6140 SOUTHMOOR DRIVE

SITE DEVELOPMENT PLAN

NOTES

**LANDSCAPE
PLAN**

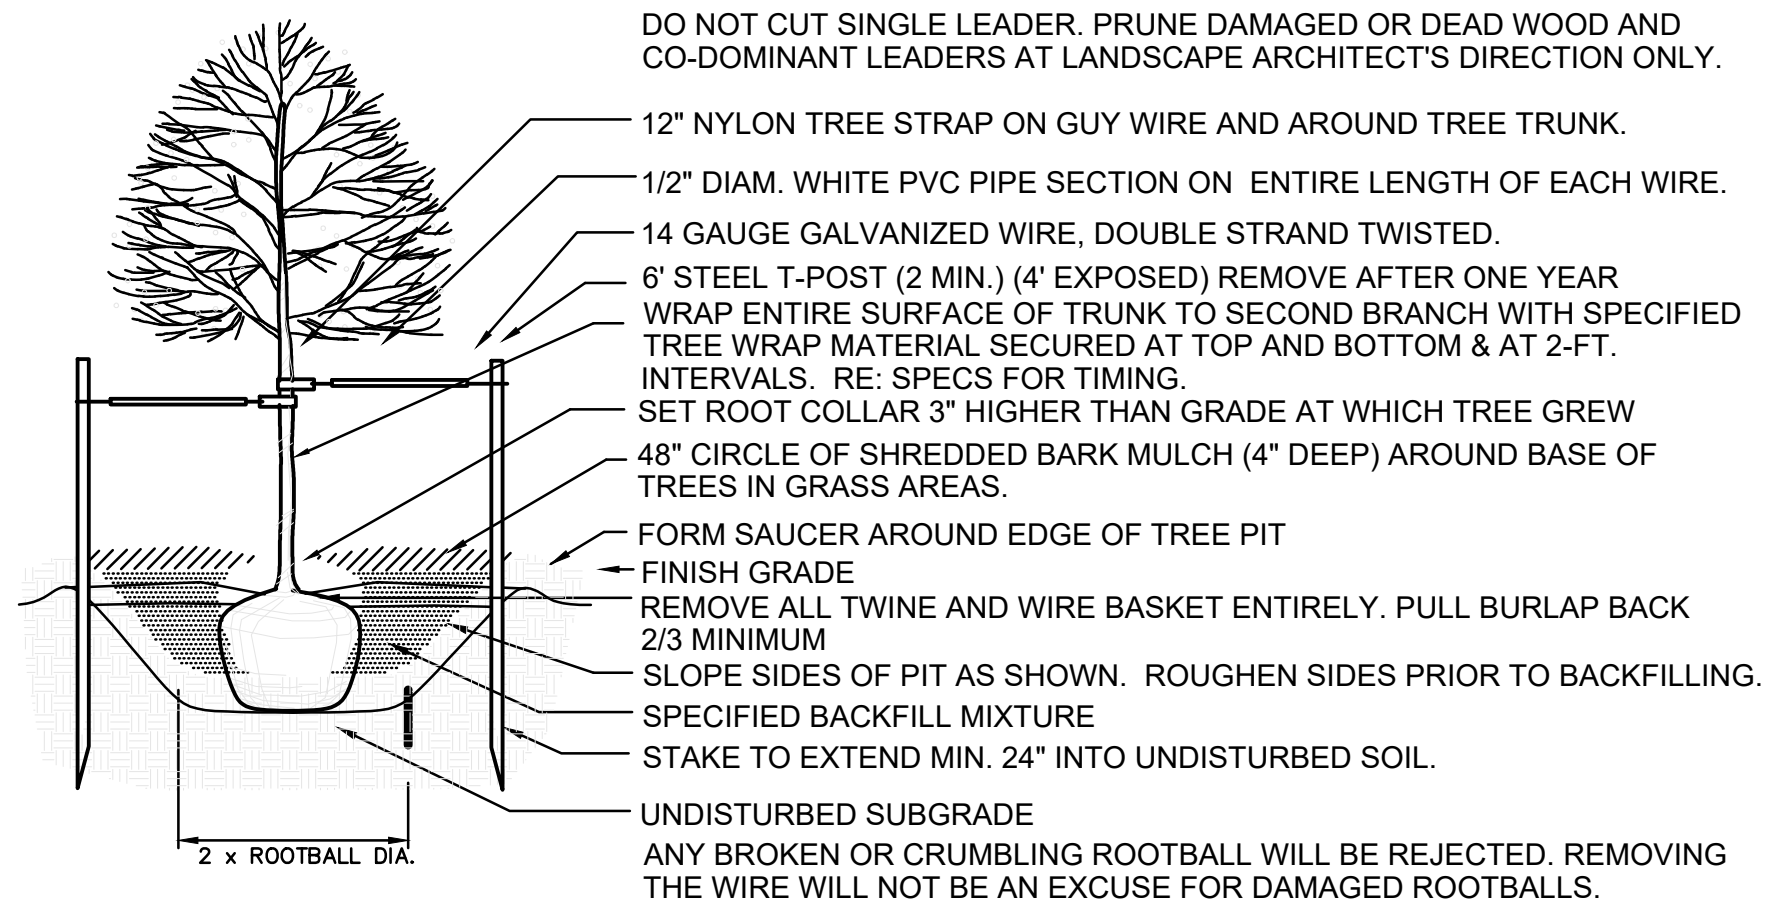
Please show required and provided under 6.2.2.B (roadway landscaping) and E (internal landscaping) of the Land Development Code
